CITY OF COCOA
Planning & Zoning Board /
Local Planning Agency
City Council Chambers

AGENDA
Special Meeting
June 25, 2019
6:00 p.m.

Date:	June 19, 2019
Project Name:	Large Scale Site Plan – 850 Cidco Rd.
Project No.:	PZ-19-00200015
Meeting Date:	June 25, 2019
Planner:	Dodie Selig, AICP, Planning & Zoning Manager
Applicant:	Dale Coxwell Coxwell Holmes Family Limited Partners PO Box 410276 Melbourne, FL 32941
Property Owner:	Dale Coxwell Coxwell Holmes Family Limited Partners PO Box 410276 Melbourne, FL 32941
Project Location:	The property is identified as 850 Cidco Road, Cocoa, Florida. (Parcel ID: 24-35-12-00-6)
Requested Action:	**APPROVAL OF A LARGE-SCALE SITE PLAN** for 850 Cidco Road consistent with Appendix A, Zoning, Article III, Section 1(D), to construct a new industrial fabrication building, along with additional concrete equipment pads and associated parking.

Drawing Number: C-202
Revision:

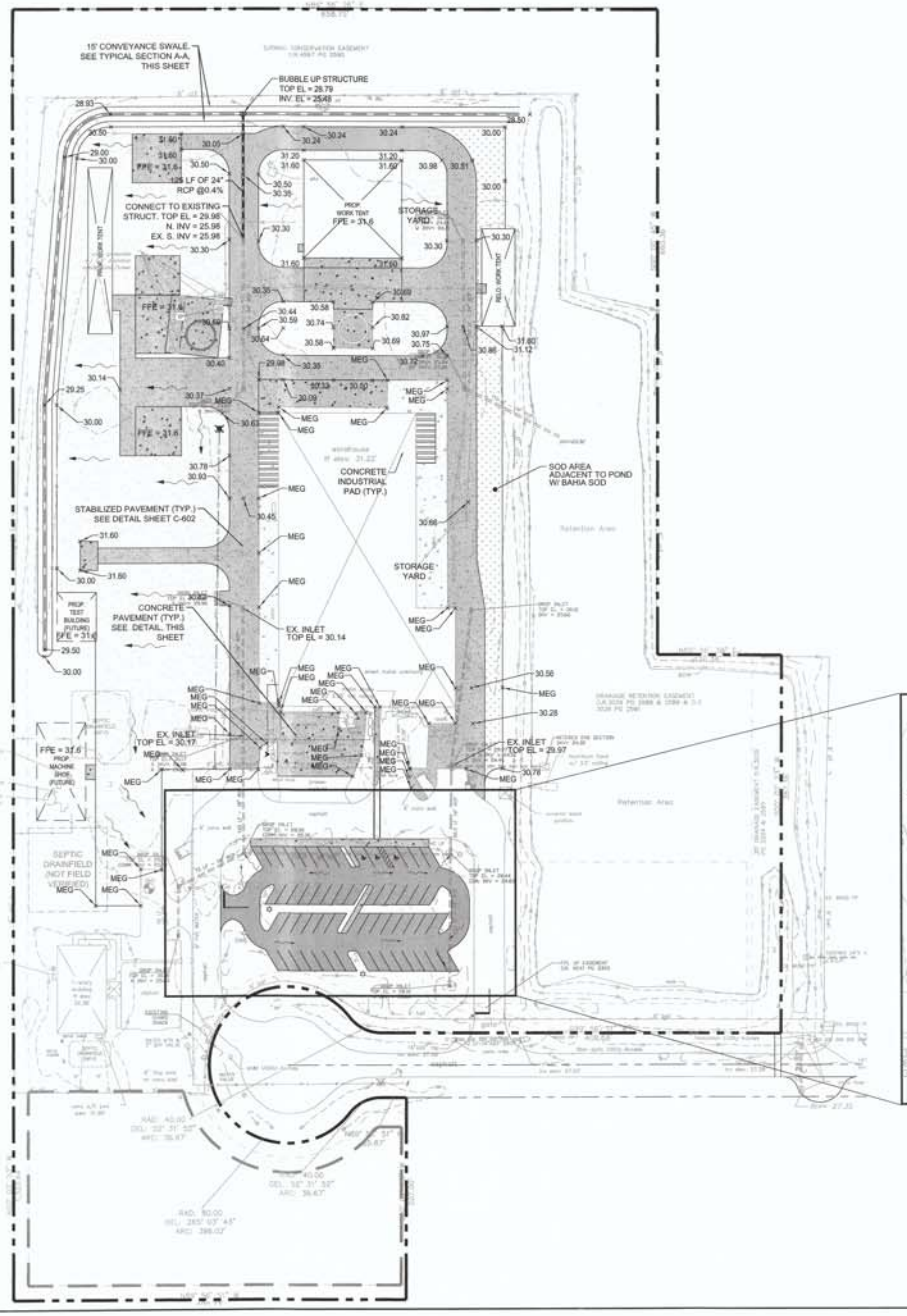
City staff has reviewed the site plan and determined that all criteria related to the City Code have been satisfied. However, on page C-202 the Special Exception Approval Note needs to be modified as follows, "PZ-19-00000008 – Special exception request from Appendix A, Zoning, Article XI, Section 19 (c) (1) of the City of Cocoa Code to allow for a principle structure in excess

of 60’ in height and up to a maximum of 120’ in height in the M-2 (Manufacturing and Industrial) zoning district.” This modification has been added as a condition of final site plan approval.
